SURVEY FOR
SHELLY SLIMP

**LOT 11
 TANGLEWOOD NORTH**

PETITION No.: V-170

TYPE OF VARIANCE: Increase the maximum allowable impervious surface from 35% to 40%.

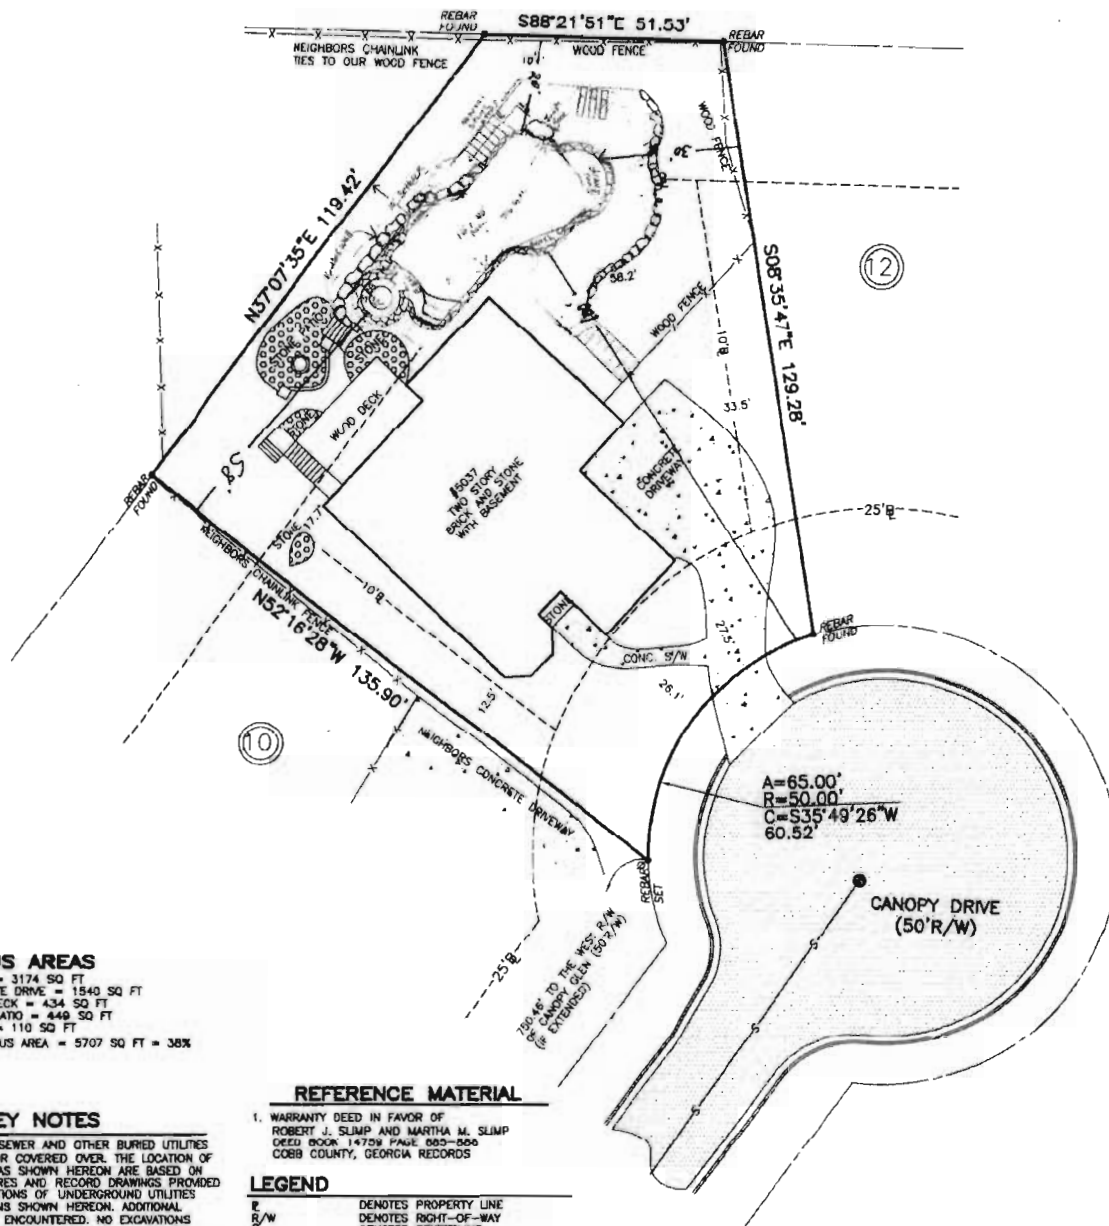
SITE PLAN REVIEW: If this variance request is approved, a subdivision plat revision must be recorded prior to the issuance of the letter of completion showing all improvements on the lot and referencing the variance case in the standard plat revision note. The surveyor must submit the plat to the Site Plan Review Section, Community Development Agency for review and approval prior to recording. Call 770-528-2147.

STORMWATER MANAGEMENT: This lot is already over the 35% allowable impervious coverage for an R-15 parcel. The proposed improvements will increase the effective coverage to 40%. If the variance is approved, it should be subject to the installation of a dry-well system to mitigate the increase in stormwater runoff. The system design must be approved by the Stormwater Management Division prior to issuance of a building permit.
